UNITED STATES PATENT AND TRADEMARK OFFICE

APPLICATION NO.	FILING DATE	FIRST NAMED INVENTOR	ATTORNEY DOCKET NO.	CONFIRMATION NO.
09/585,472	06/02/2000	Michiaki Sakamoto	157330/99	6609
21254	7590	03/22/2004		
MCGINN & GIBB, PLLC 8321 OLD COURTHOUSE ROAD SUITE 200 VIENNA, VA 22182-3817			EXAMINER RUDE, TIMOTHY L	
			ART UNIT 2871	PAPER NUMBER

Office Action Summary

DETAILED ACTION

FIG. 6(c)

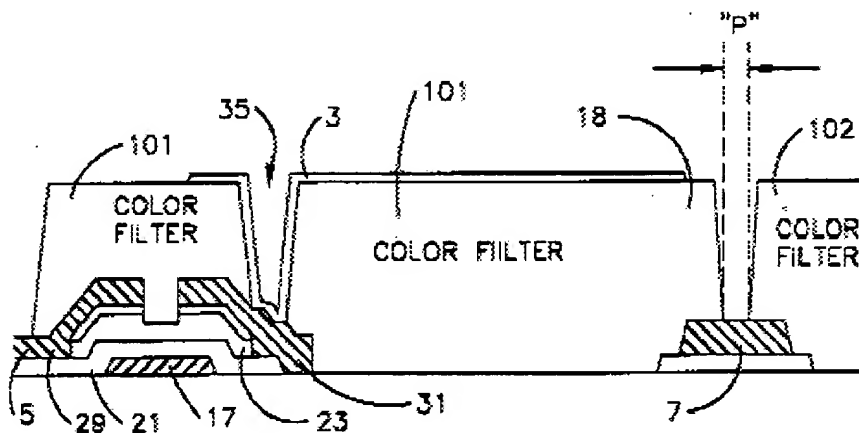
As to claim 1, Zhong discloses (entire patent, especially Figures 6(a)-6(c) and 11) an active matrix liquid crystal display device (col. 8, line 22 through col. 11, line 28), comprising: a first substrate, 19, and a second substrate, 51, at least one of said first substrate and said second substrate being transparent; a plurality of scanning lines, 7, formed on said first substrate; a plurality of signal lines, 5, formed on said first substrate crossing said scanning lines in a matrix manner a plurality of thin film transistors, each said thin film transistor respectively formed at an intersection of said scanning lines and said signal lines, each said thin film transistor comprising: a gate electrode, 17, formed on said first substrate; a gate insulation layer, 21, formed on said gate electrode; a semiconductor layer, 23, formed on said gate insulation layer; a drain electrode, 29, formed on a first portion of said semiconductor layer and a first portion of said gate insulation layer; and a source electrode, 31, formed on a second portion of said semiconductor layer and a second portion of said gate insulation layer; at least one color filter, 101, formed on said first substrate; a plurality of pixel electrodes, 3, each respectively connected to one of said thin film transistors through a contact hole, 35, and each respectively formed on one of said at least one color filter; a counter electrode, 49, formed on said second substrate; and a liquid crystal layer, 45, between said first substrate and said second substrate, said liquid crystal layer being driven by electric fields between said pixel electrodes and said counter electrode to thereby make a display, wherein said color filter is formed directly on said first substrate (per Figure 6(c)) in most of a light transmission region within a pixel area surrounded by said scanning lines and said signal lines, and said color film comprises a stack of layers that

reduces a thickness of material of said color filter near said contact hole such that a portion of said stack of layers remains in place adjacent to said contact hole (per Figure 6(c)).

As to claim 3, Zhong teaches the use of a color filter, 101, around said contact hole, 35, that is thinner than the color filter in said light transmission region (Figure 6c).

Zhong teaches the use of a color filter, 101, consisting of a photosensitive organic film (resist) with a color pigment or dye (col. 16, lines 43-46) that is substantially flat on the top surface (as illustrated in Figure 6c), therefore a difference in level generated on a surface of the organic film being not more than $0.3\text{ }\mu\text{m}$ as a results effective variable for reducing line-pixel capacitances (Abstract) (MPEP 2144.05 II B).

As to claim 11, given the structure of Zhong (Figure 6c) and a passivation layer of Ohta exclusively on and in direct physical contact with the TFT, the vias, 35, formed in the color filters, 101, would necessarily be also formed in the passivation layer in order to allow electrical contact with source electrodes, 31 (consistent with both Zhong and Ohta).

As to claim 12, Zhong discloses a substantially flat color filter, 101, so that a first portion of said color filter filling said pixel opening is larger in thickness than a second portion of said color filter covering said passivation film per Figure 6(c).

As to claim 14, Given the structure of Zhong (Figure 6c) and the passivation layer on the TFT of Kawabe, the color filter extends (as illustrated in Figure 6c) and it would cover said transistor with an intervention of said passivation film.

FIG. 3

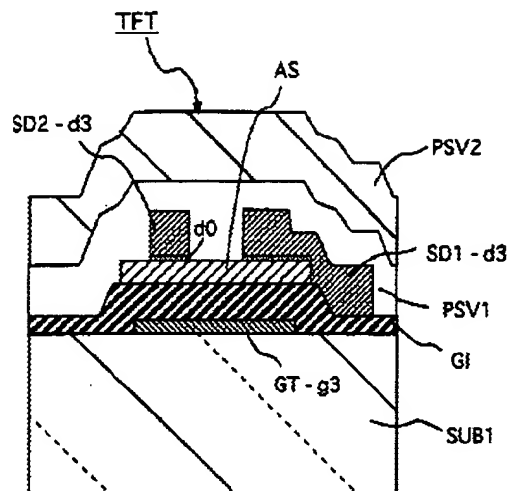
Ohta teaches the use of a passivation film exclusively over and in direct physical contact with the TFT portions to protect a back channel portion of the TFT and thereby stabilize a threshold voltage, V_{th} (col. 8, lines 34-67) without warping of the substrate caused by the stress of said passivation layer. Please note that modification of the device of Zhong with the passivation film of Ohta would result in said passivation film and said color film form a stack of layers that reduces a thickness of material of said

color filter near said contact hole such that a portion of said passivation film remains in place adjacent to said contact hole.

Ohta is evidence that ordinary workers in the art of liquid crystals would find the reason, suggestion, or motivation to add a passivation film exclusively over and in direct physical contact with the TFT portions wherein said passivation film and a color film form a stack of layers that reduces a thickness of material of the color filter near said contact hole such that a portion of said passivation film remains in place adjacent to said contact hole to protect a back channel portion of the TFT and thereby stabilize a threshold voltage, V_{th} , without warping of the substrate caused by the stress of said passivation layer.
